110 FIRST AVE WEST

SDCI LAND USE REVIEW
CORRECTION NOTICE #1
(Issued 01/03/19)

18.1 ALLEY CORNER CONDITION & DETAILS

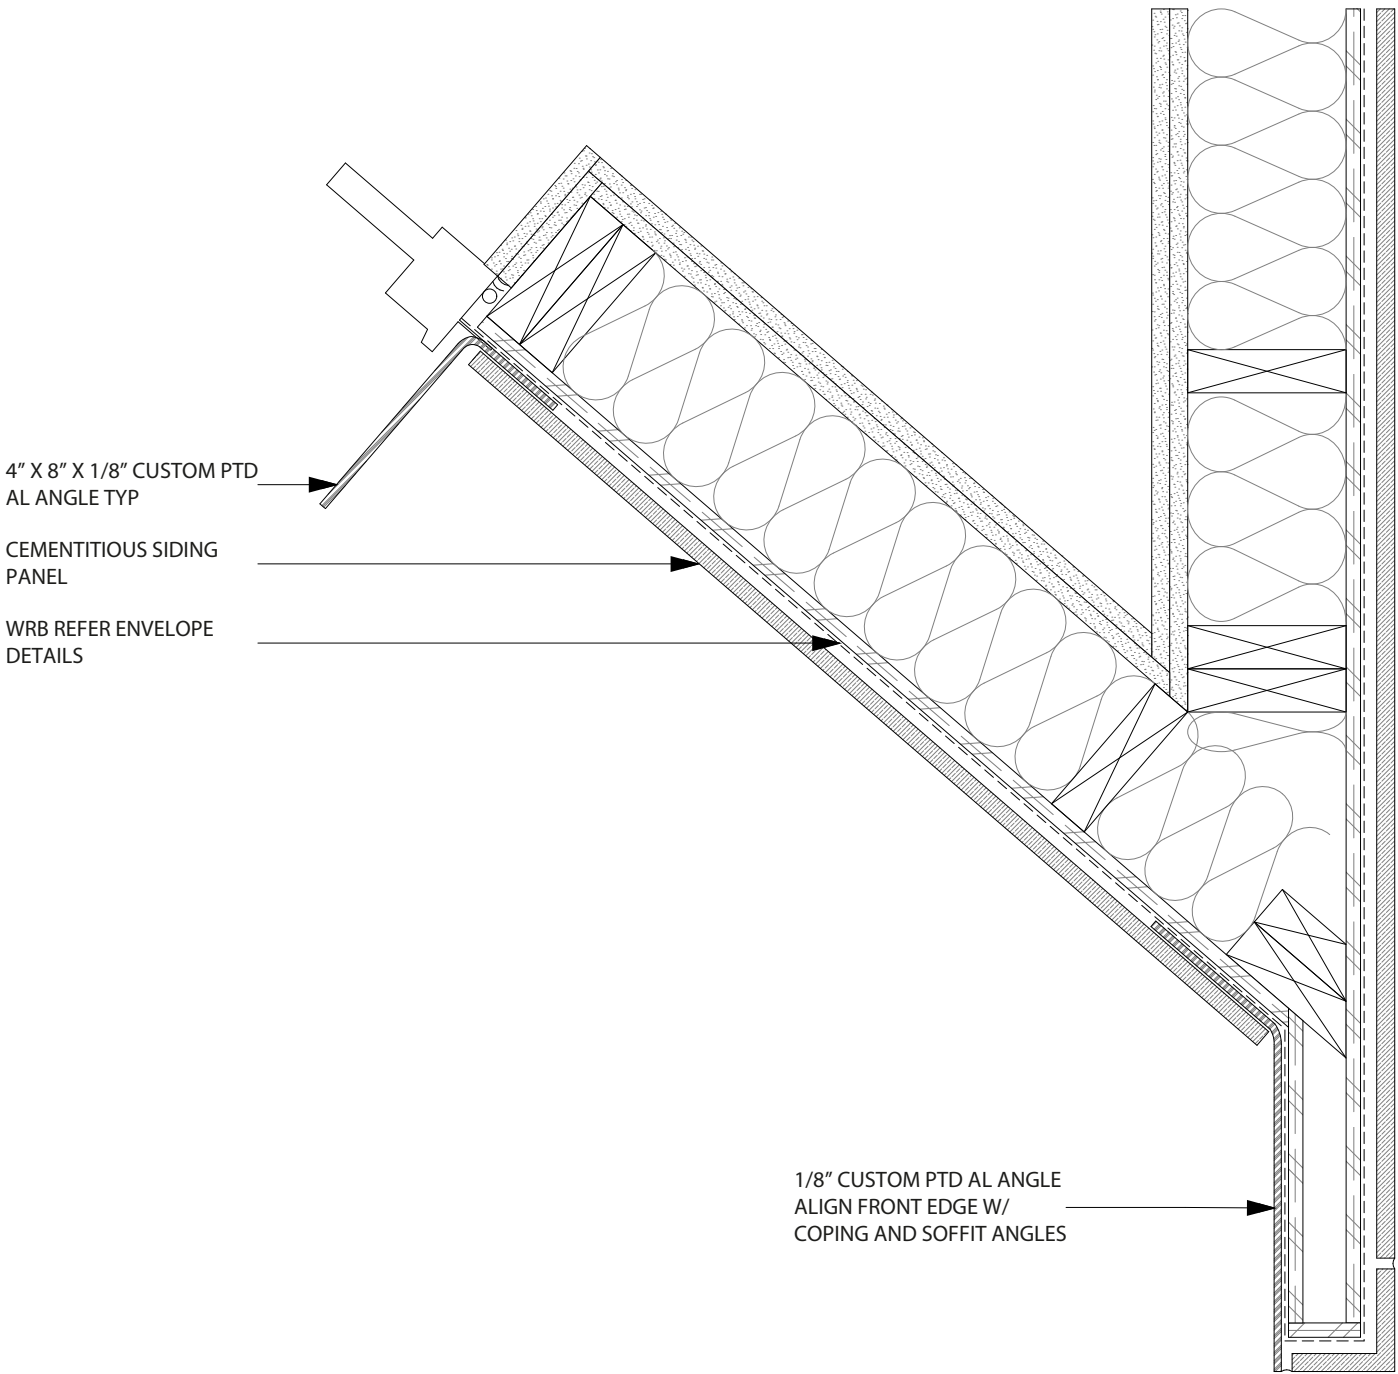
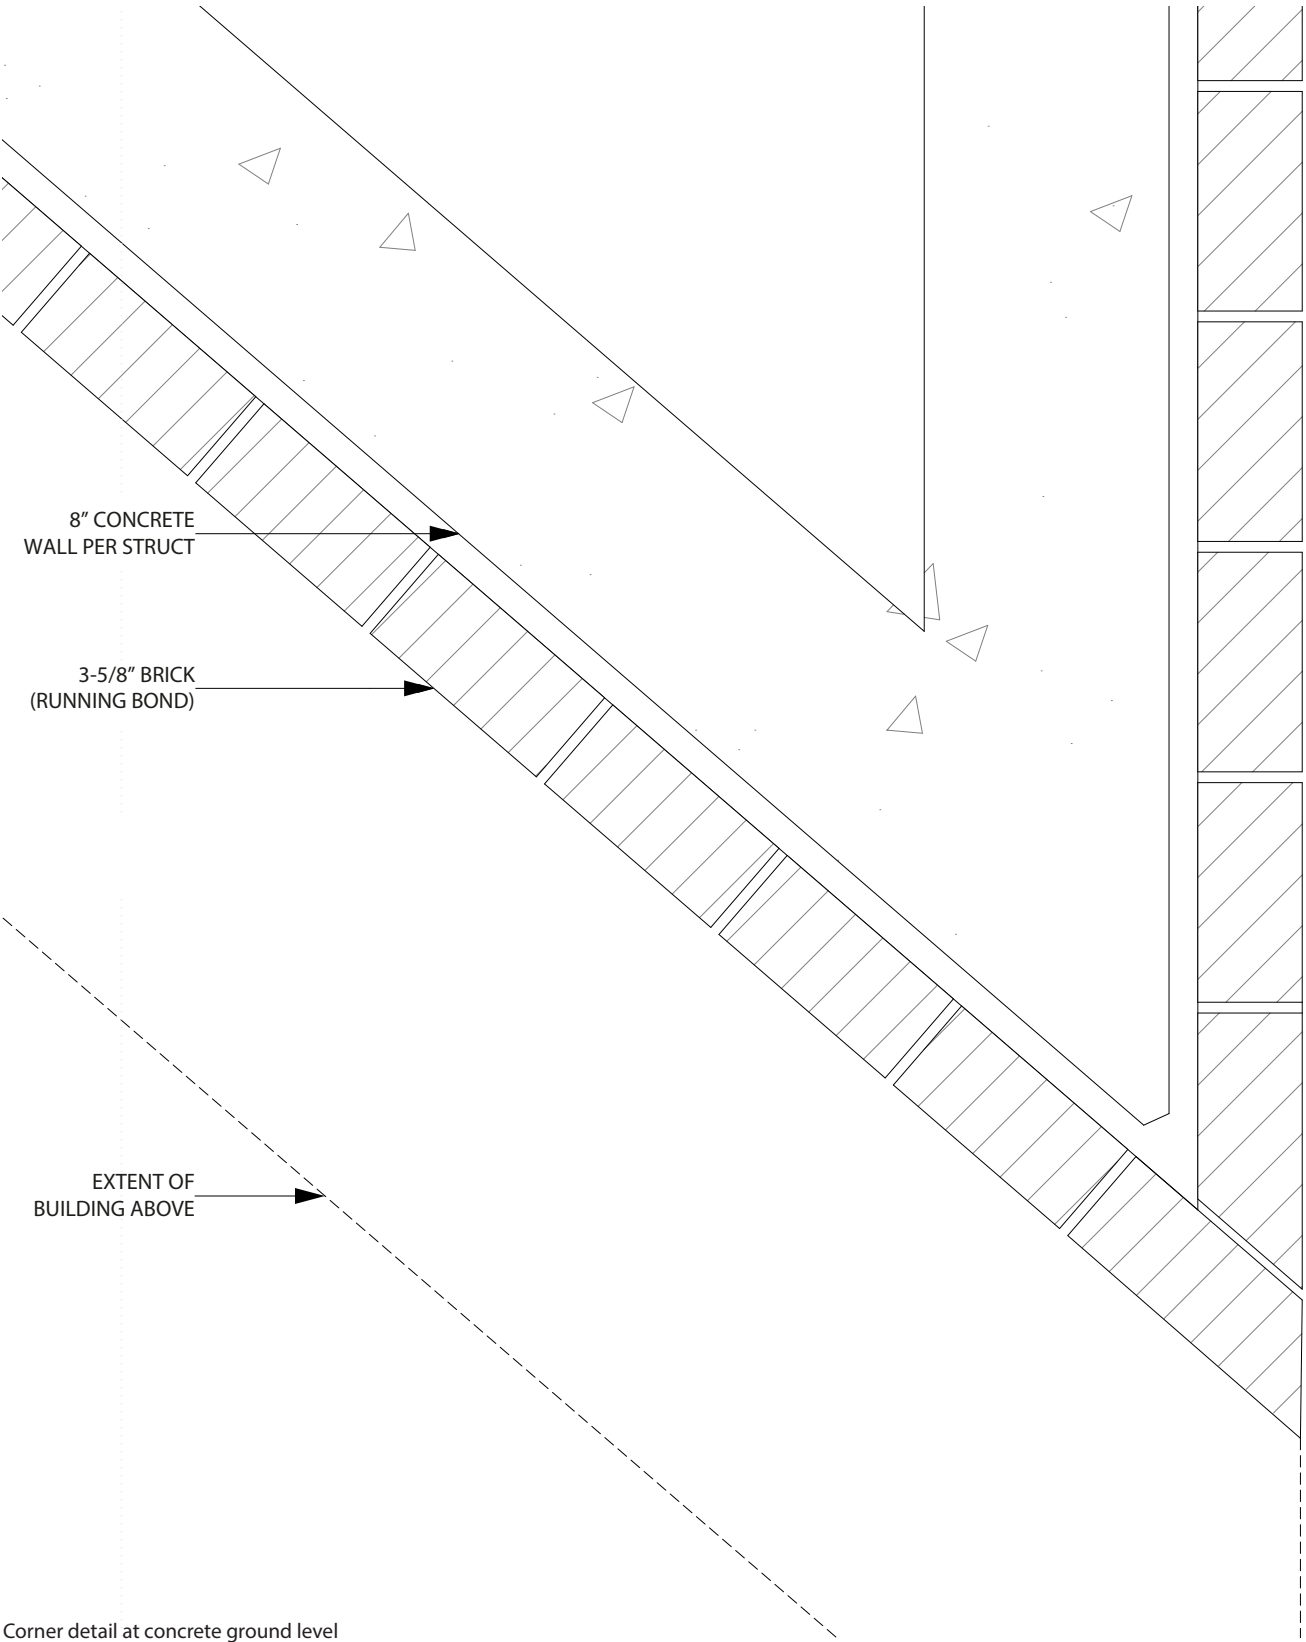
5. Alley prow

The board discussed the alley corner at length. The proposal uses the striking angle to satisfy their request for a dynamic an engaging design at this location. Please include a detail of the corner assembly so that the board can assess the success of this striking corner feature.

A similar strategy of breaking the building’s mass into two distcint volumes is carried around the corner and along the facade facing the alley. Materials identical to those on the Western Ave facade wrap the south-eastern prow at the upper and lower levels to provide a consistency of concept between the street and alley façades.

Two details of the southwest corner assembly are included on page 49. One detail documents the corner condition at street level while the other does so at the typical upper levels.

Corner detail at wood upper levels

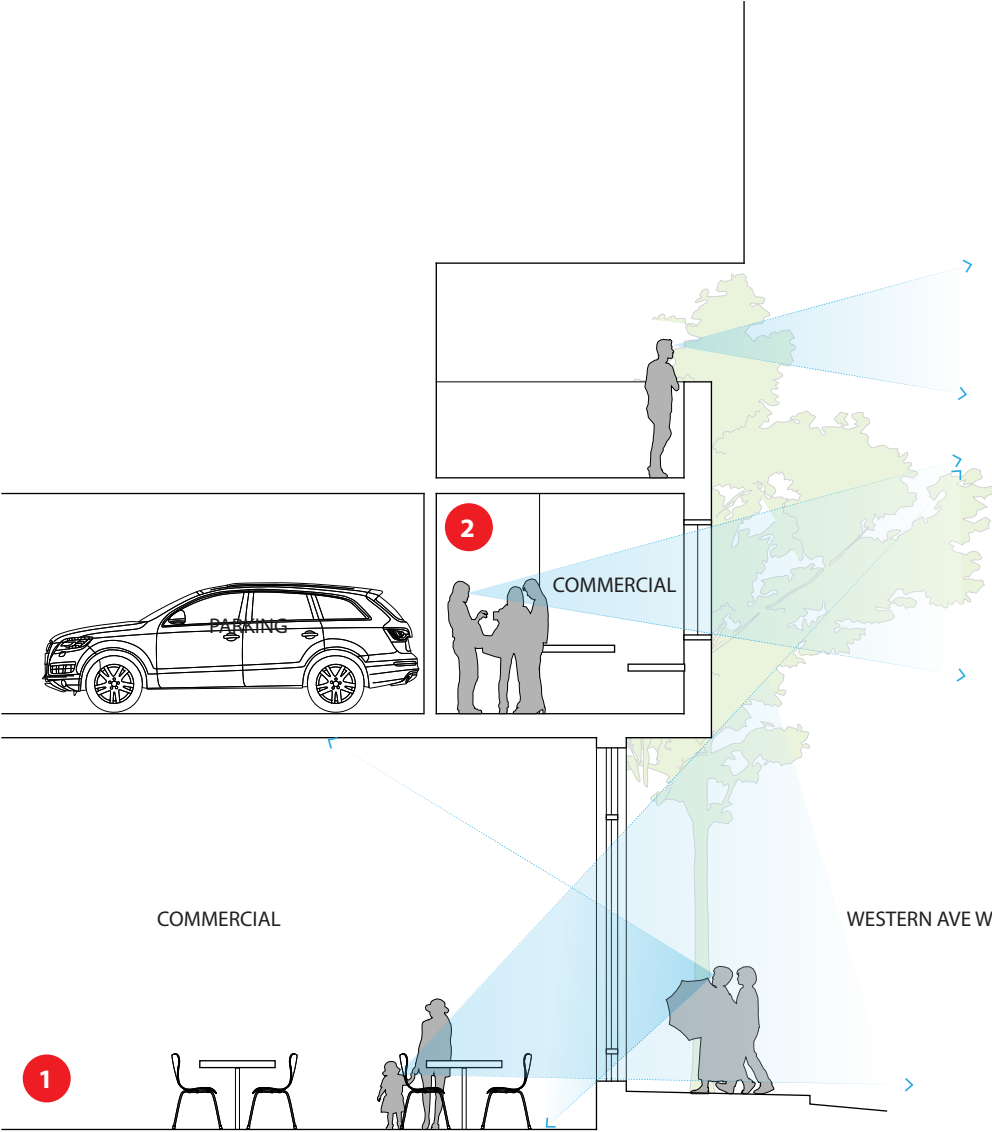
In order to evaluate whether the proposed fiber cement panel will be used in a manner that results in appearing as a high quality material per DC4-A, provide details regarding panel scale, material thickness, use of integral color, joint detailing, flashing and trim quality (gauge), as well as overall composition.

Response: Architectural details regarding panel scale, material thickness, use of integral color, joint detailing, flashing and trim quality as well as overall composition are included in this DRB packet on the elevations, pages 31-35, and page 49.

Section through Level 1 and Level 2 showing views in and out of the proposed commercial space.

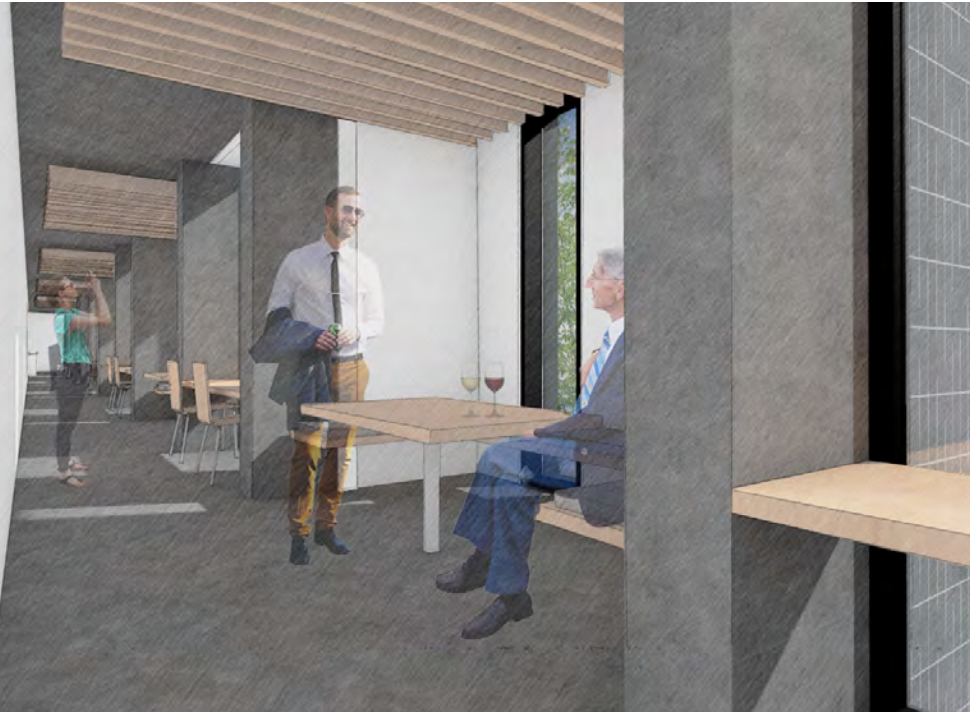
4. Activate the mezzanine

Activate the mezzanine that shrouds the parking garage. This could be achieved using a contrasting color, increasing fenestration or by using colored glass in the small slots at this level. Activation of this space is critical to successfully shrouding the parking garage in a way that meets code.

Response: 100% of the parking level is screened from both streets by intervening uses. The second floor of the commercial space screens the parking level from Western Ave W while a residential amenity lounge does so along First Ave W. Both the street and second levels are activated by the use of windows and articulated bays through which a pedestrian passerby and motorists alike can experience activity within the building (particularly in the evenings as these spaces are lit from within).

18.2 STREET-LEVEL TRANSPARENCY & ACTIVATION

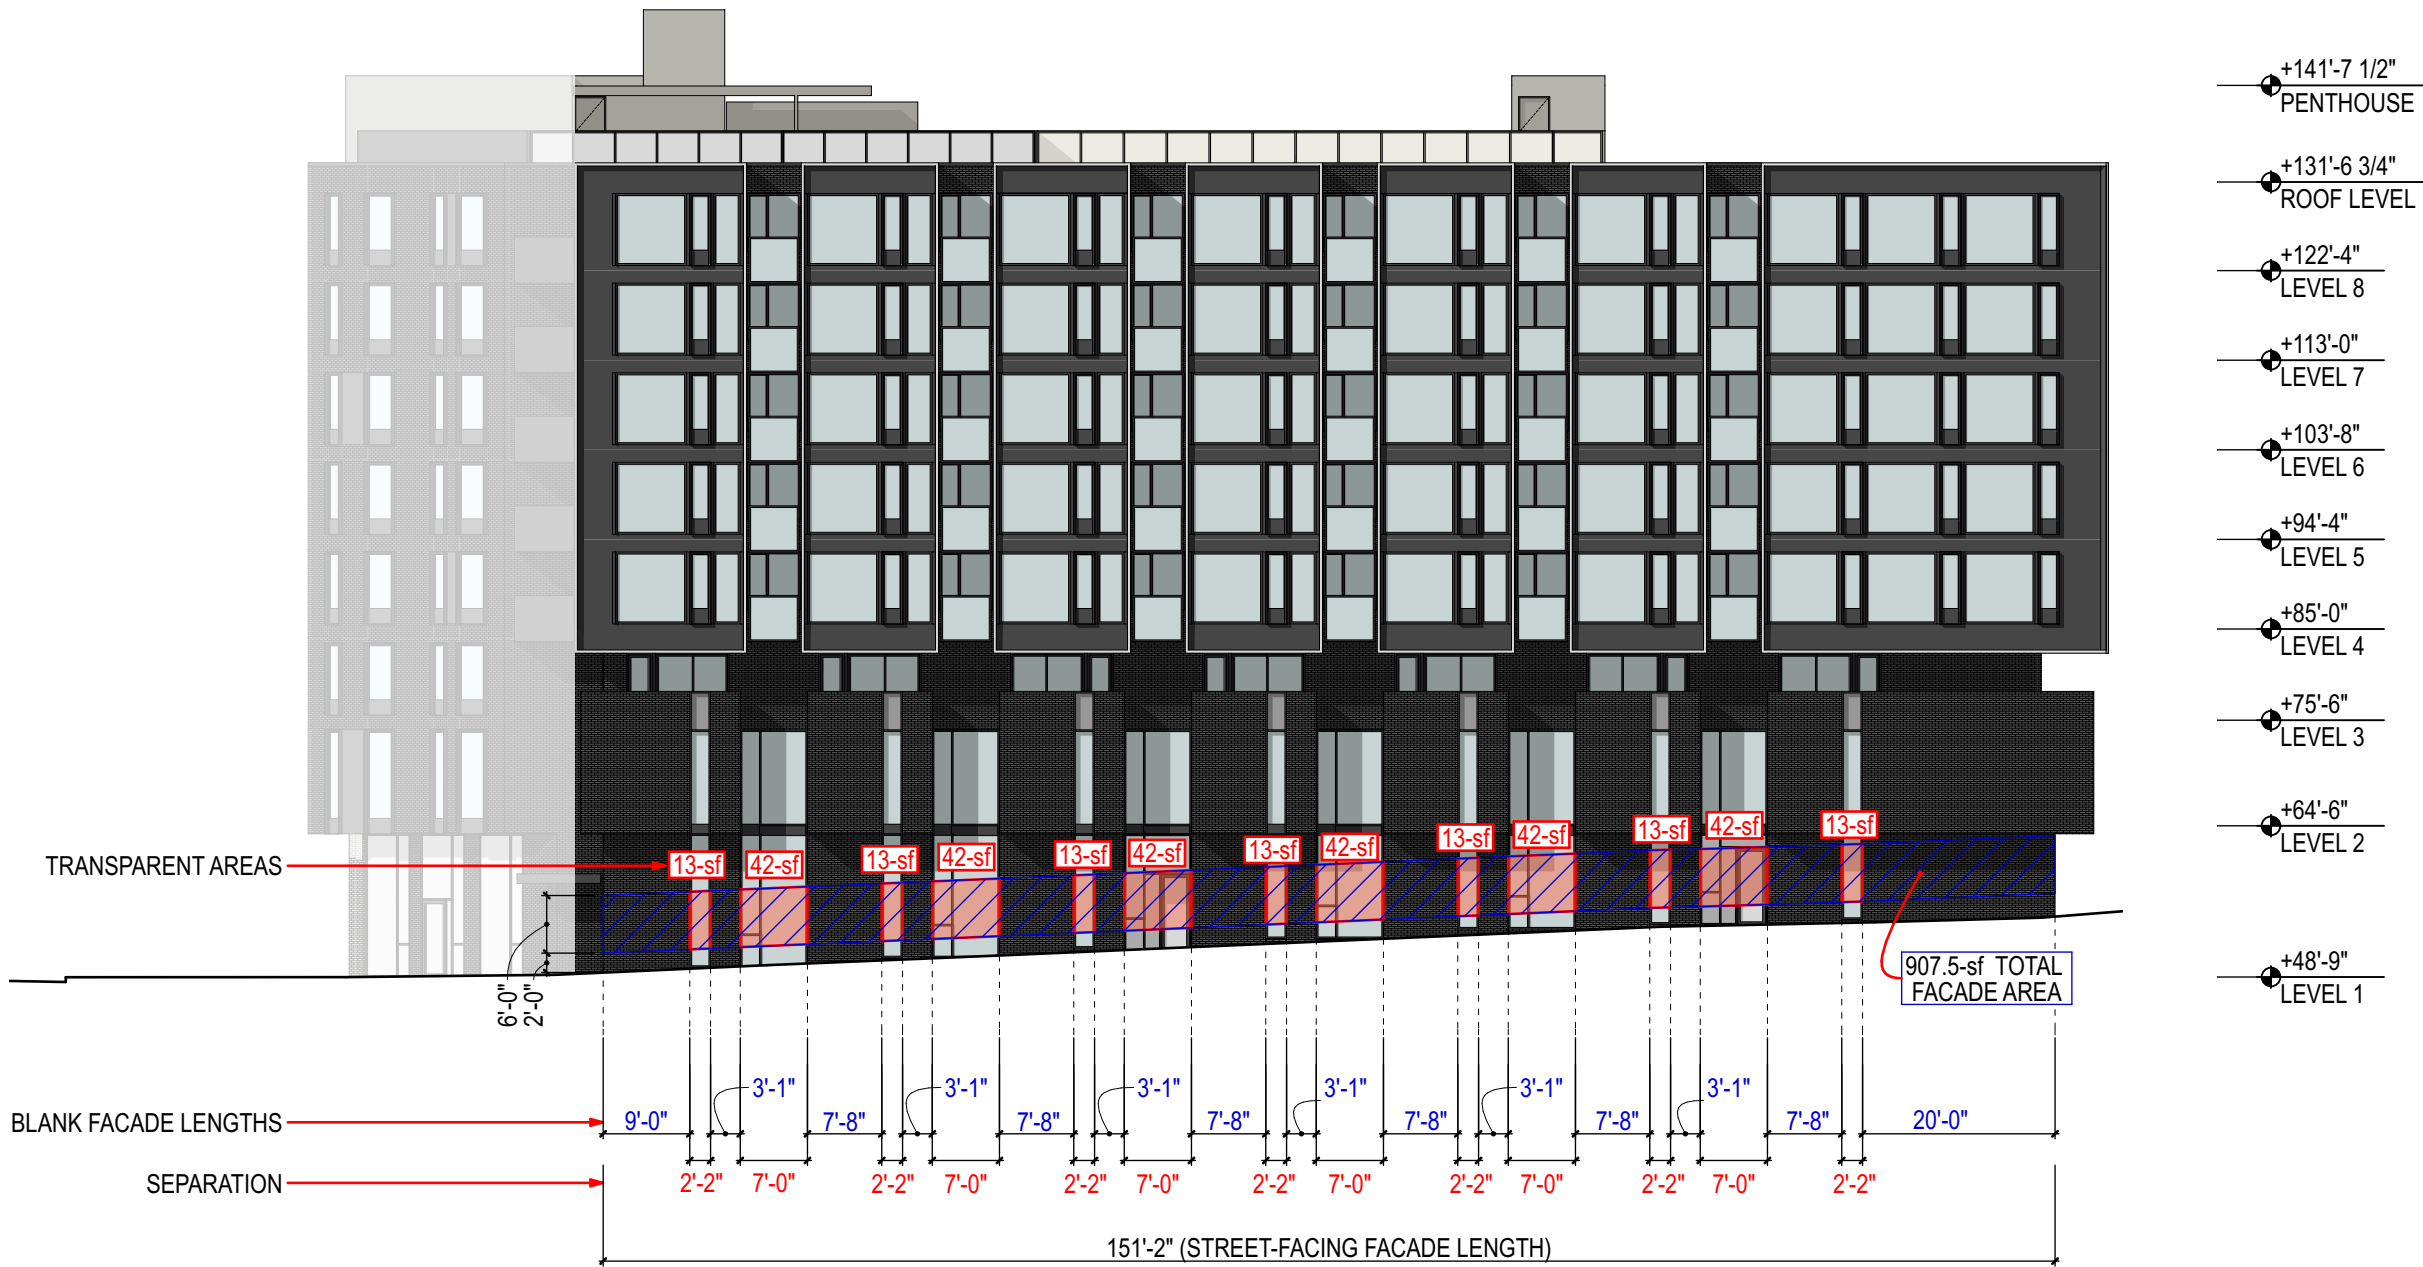
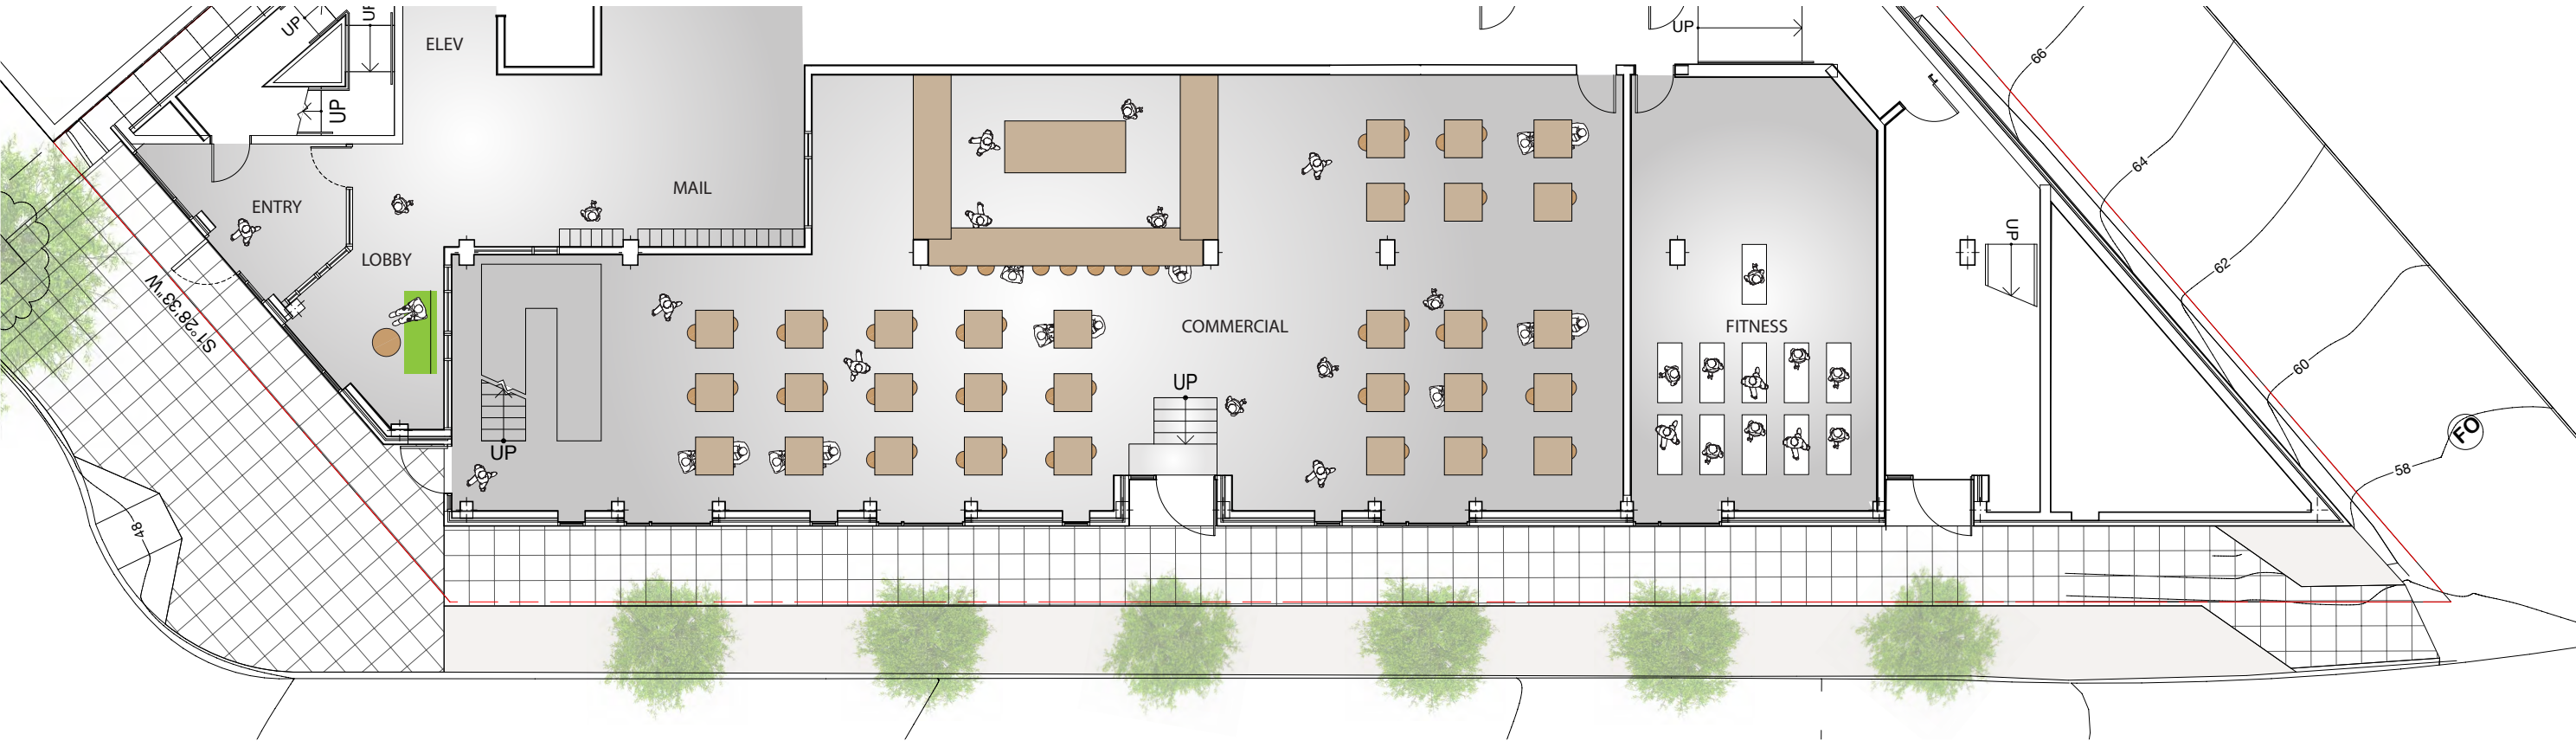
d. Board members requested that the applicant consider placing extra entrances along Western Ave. The Board also stated that the next proposal must include a significant amount of transparency on the street. (PL 3)

Response: Additional entrances have been placed along Western Ave W. One will serve as a secondary entrance to the commercial space and another serves as the secondary entrance to residential areas and amenities on the first level.
